Comments from reviewer

rebound test

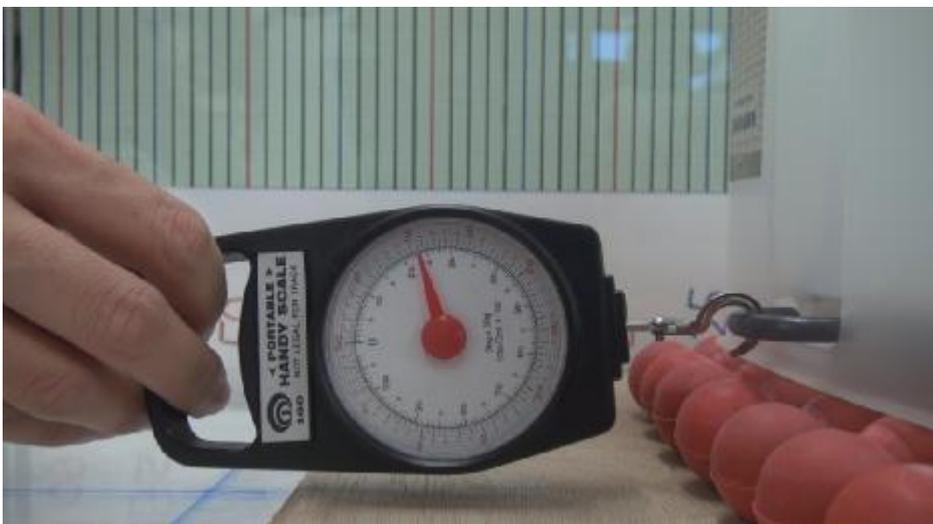
3. Figs. 4 and 5 can be removed or presented schematically. Fig. 6 is insignificant.
4. The procedure and details to determine frictional coefficients in Table 1 should be added for verifications. Only those tests related to current study should be included in this manuscript.

1. The introduction part has been shortened to include more relevant materials only.
2. Eqs.(1) and (2) are removed. Thanks to the comments.
3. The authors personally view that Fig.4 and 5 can be retained. Some readers may want to see the actual photos of the flume and the end process. In particular, other reviewers do not have such comment, hence the authors prefer to retain these figures, unless there is a strong comment on it. Similarly, the authors view that Fig.6 is actually useful, as the photo give a clear view about the nature and texture of the balls.
4. The frictional coefficients in Table 1 are provided by the manufacturers, while the parameters in Table 3 are determined by in-house testing procedures. The testing procedures are provided in the section just before Table 3.

Deposition test

shear

force applied to determine the frictional coefficients between balls.

5. Line 210-220 – as mentioned in many places in the revised manuscript, due to the limitations of DEM, it cannot provide a good quantitative description of the flow process, up to the present. It is also not the purpose of the present manuscript to address this issue. However, the authors are also working on this issue to improve the quantitative assessment by using DEM, while the general procedures are to fine-tune the parameters until the computed results match well with the measured results. Personally, the authors do not favour this approach, as we can tune everything to match with experiments, even if the theory is wrong.
6. The determination of the parameters are based on laboratory tests, as given in the revised manuscript. A sample test report for the deposition test is given below, while the values as given in Table 3 are the mean values.
